Sub Region RTEP Mid-Atlantic Committee DPL Supplemental Projects

DPL-2021-001 Updated Scope

Need Number: DPL-2021-001

Process Stage: Solutions Meeting 4/20/2023

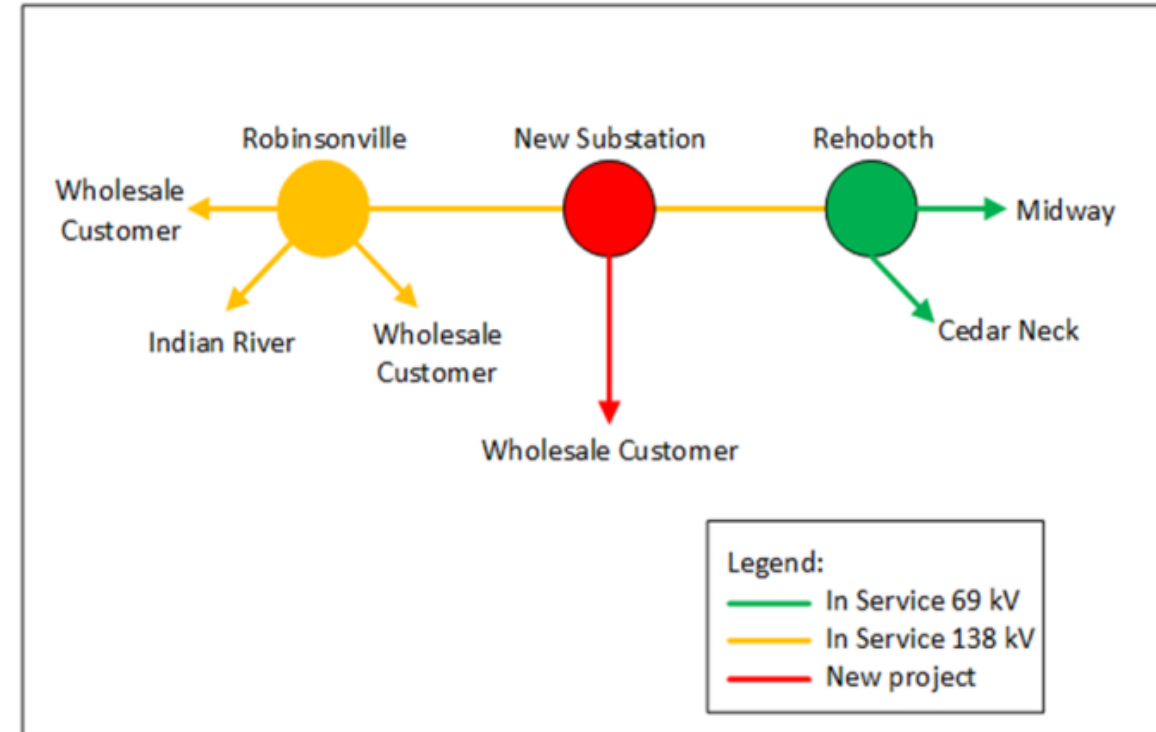
New Scope:

- Construct a new 4-breaker ring bus substation with a capacitor bank tying into to the Robinsonville – Rehoboth 138kV line with a terminal position dedicated to the customer

Old Scope:

- Construct a new 3-breaker ring bus substation tying into to the Robinsonville – Rehoboth 138kV line with a terminal position dedicated to the customer

Old Estimated Cost: \$9.75M

New Estimated Cost: \$10.5M
